**REVISED CORE OPERATING LIMITS REPORT - CYCLE 13  
SALEM GENERATING STATION UNIT NO. 2  
FACILITY OPERATING LICENSE DPR-75  
DOCKET NO. 50-311**

**CORE OPERATING LIMITS REPORT - CYCLE 13  
REVISION 1**

NFS-0209  
Revision 1  
June 2002

AXIAL FLUX DIFFERENCE LIMITS AS A FUNCTION OF  
RATED THERMAL POWER

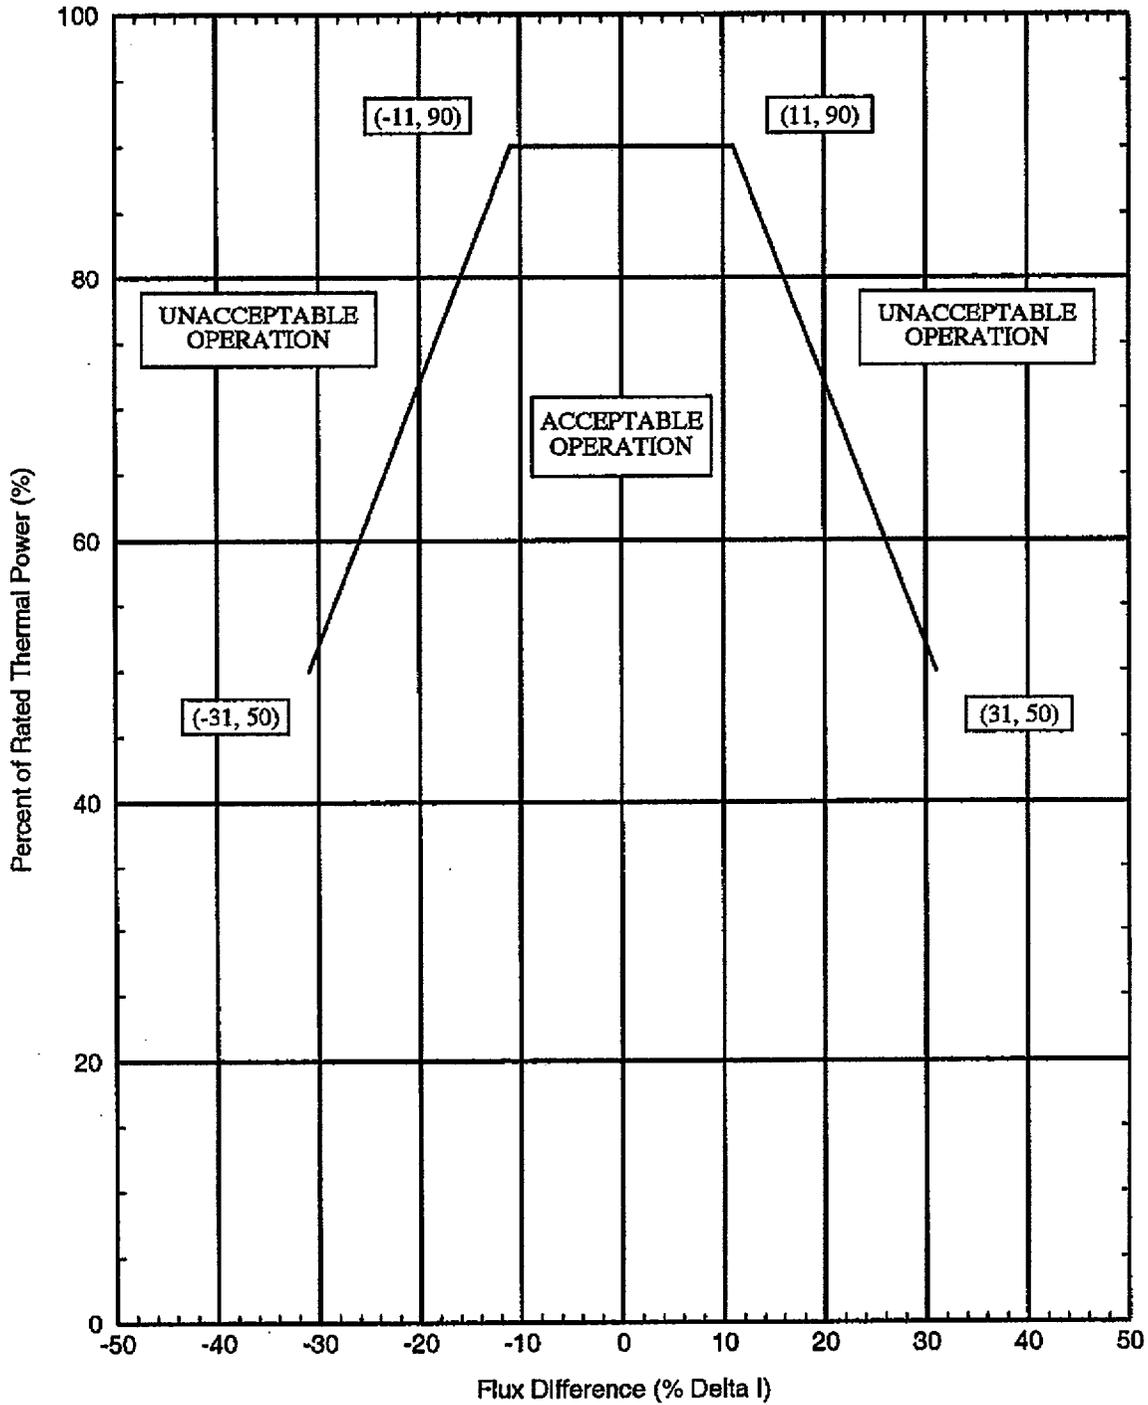
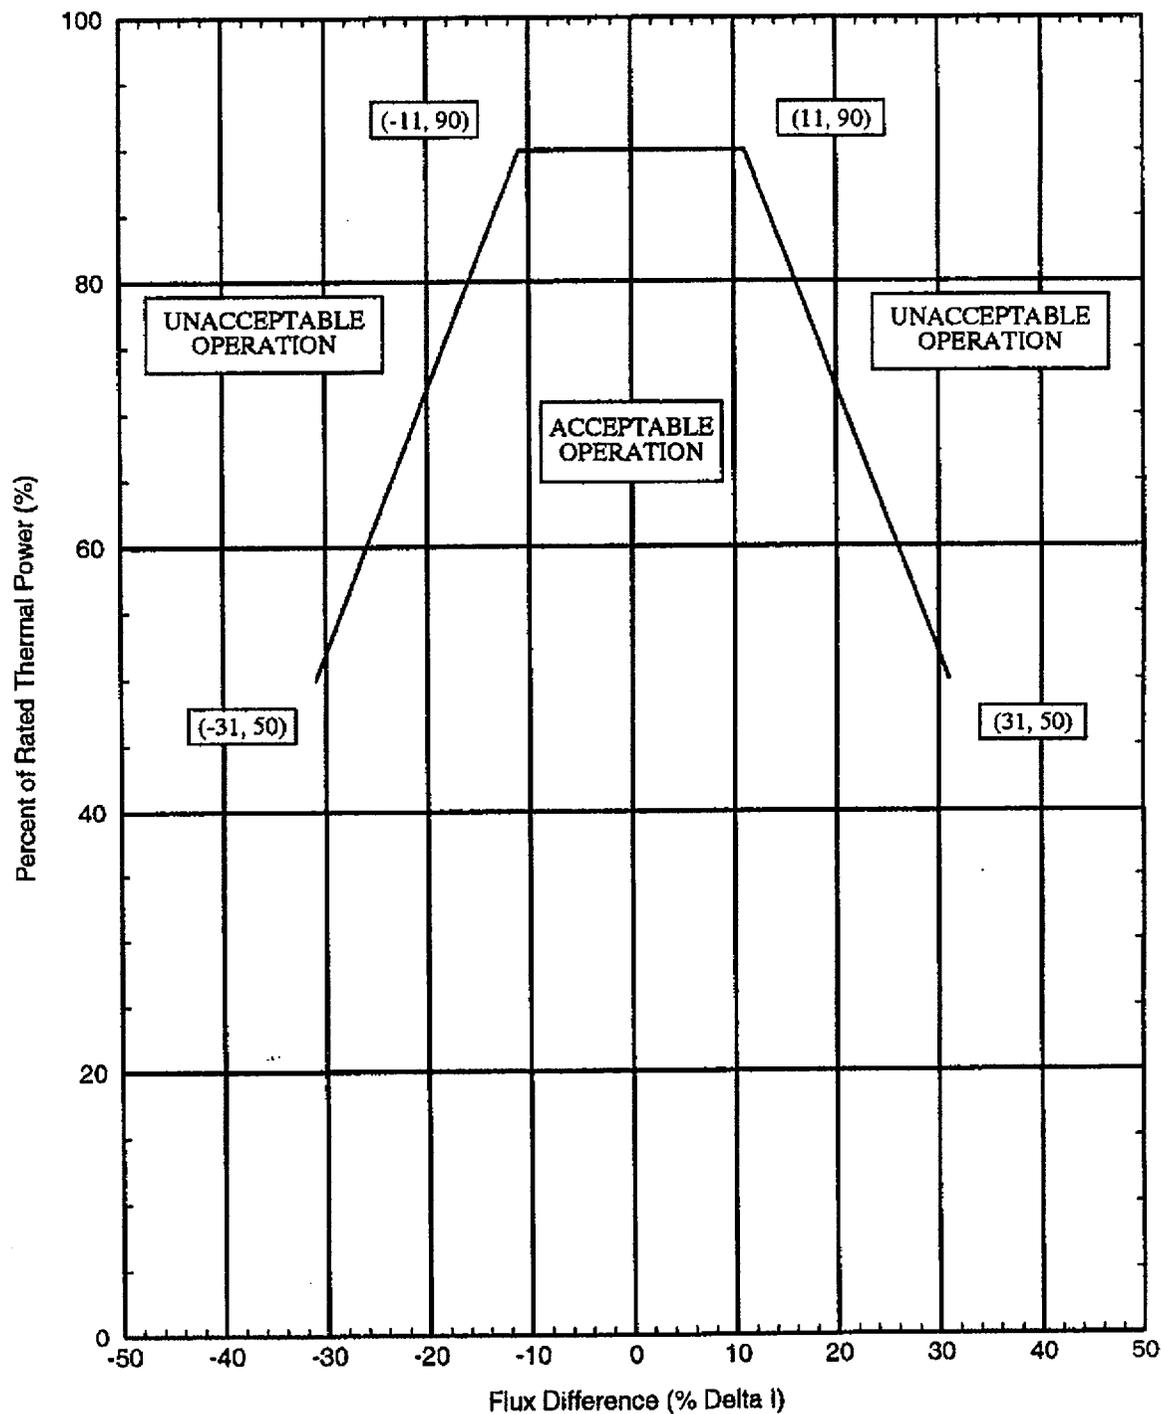
Revision 1 of the COLR clarifies section 2.3, noting that a more restrictive Axial Flux Difference band may be prescribed by plant procedure. Revision 2 makes administrative changes to the List of Effective Pages and to the Summary of Changes.

The purpose of Revision 1 is to modify the requirements of Section 2.3, Axial Flux Difference (Specification 3/4.2.1).

2.3.1 The Axial Flux Difference (AFD) target band shall be the more restrictive of (+6%, -9%) or the target band as defined in Reference 2.

2.3.2 The AFD Acceptable Operation Limits are provided in Figure 2.
